2016 - 2019 Cadillac CTS-V: Service Bulletin: #15-06-01-002K: Engine Misfire/Tick Noise, Malfunction Indicator Lamp (MIL) Illuminated - DTC P0300 Set - (Dec 17, 2020)

#15-06-01-002K: Engine Misfire/Tick Noise, Malfunction Indicator Lamp (MIL) Illuminated - DTC P0300 Set - (Dec 17, 2020)

This bulletin has been revised to update the Parts Information section. Please discard Corporate Bulletin Number 15-06-01-002J.

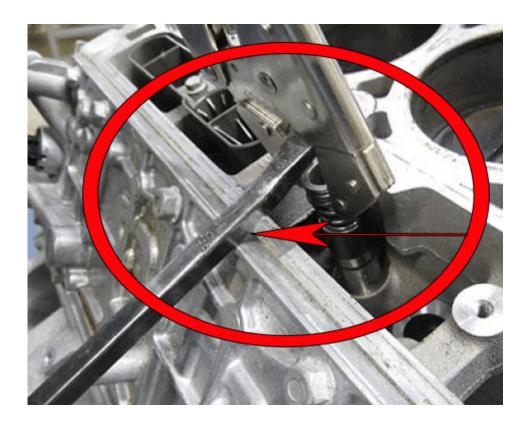
There are two approved processes for removing the lifter when stuck in the bore.

1. Use vice grips with a slide hammer.

Note: Be sure *NOT* to pry on the sealing surface of the block, as shown in the illustration above.

1. Use vice grips with a small pry bar.

Typically, one of the above approved processes will remove the lifter that is stuck in the bore. If not, the engine will need to be replaced.

With the lifter removed, be sure to inspect the bore for any damage. Typically, the lifter bores will look good with no indication of damage.
